We would like to thank the reviewer for the comments and suggestions, which have helped us to improve this paper significantly. Our detailed responses are provided point by point below.

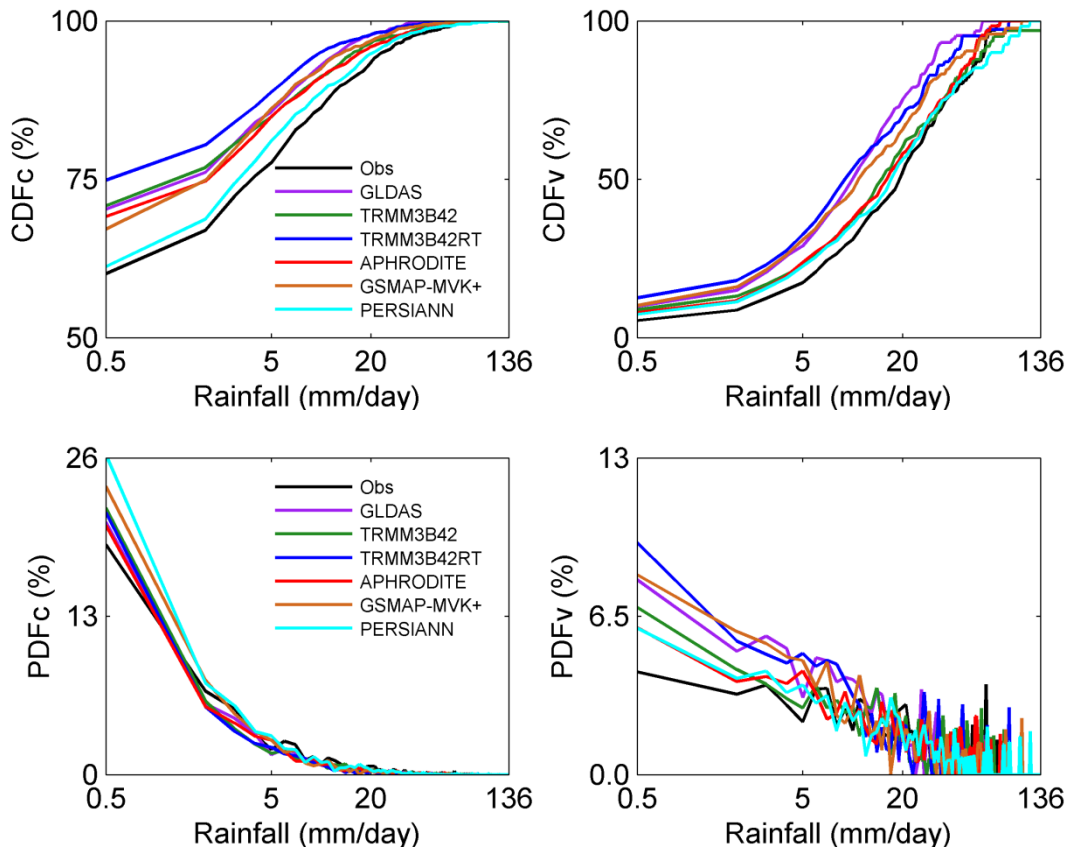
11) Page 48, Figure 10: it could be better to present PDF instead of CDF, and to include rainfall intensity less than 1mm/day.

Thanks for the suggestion. Changes have been made accordingly to include rainfall intensity less than 1mm/day. However, as shown below, the CDF figures are more clear than PDF figures. Thus, we still use the CDF figures in the revised paper.
